Service Bulletin

Using **260-0952** Alternator with Pre-2016 Stairmaster Units

Applies to: 4000-Steppers + SC916 + SC5+ FreeClimber (155015) 7000PT + SM916 + SM5+ Gauntlet (150015)

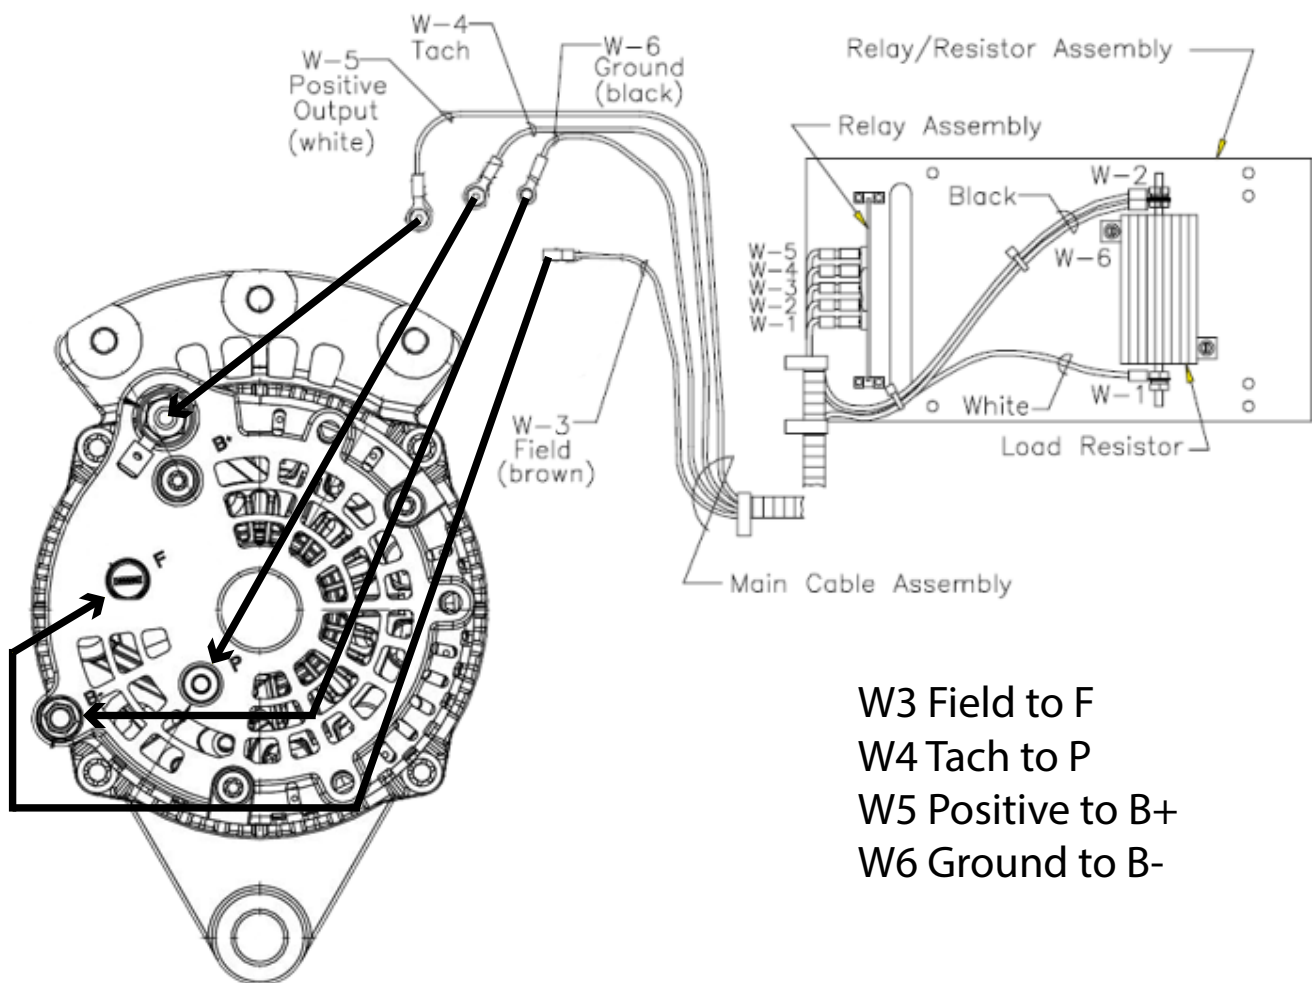
In 2018, a new alternator was introduced (**260-0952**) to replace the original Stairmaster alternator (**SM22900**). While this alternator is backwards compatible to pre-2016 units, the wires connect to it slightly different. Please see below:

W3 Field to F
W4 Tach to P
W5 Positive to B+
W6 Ground to B-
